Access Compliance Report Public Rights-of-Way (Curb Ramps)

Main Street: HUNTLEY_DR Cross Street: SHAKESPEARE_DR Location: S

ADA ID: RPRK211215135826 Ramp Type: Type 1 - Perpendicular Diagonal Initial Pass/Fail: Pass Overall Compliance: No Severity Score: 10

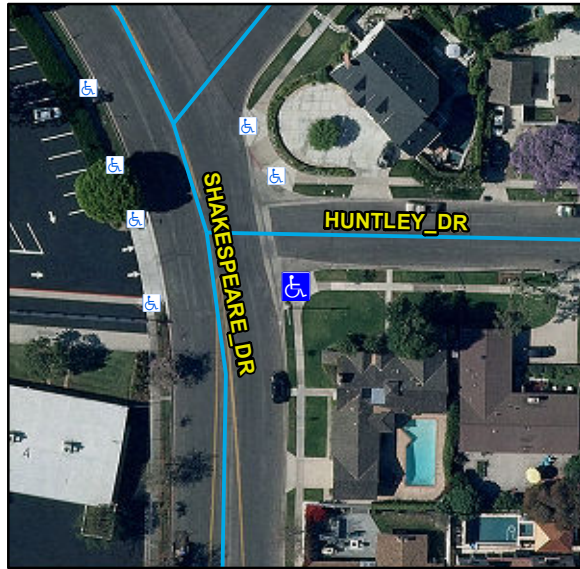
R204.3, R305, STD 1115

Remove & Replace Curb Ramp With Two New Directional Ramps or Equivalent.
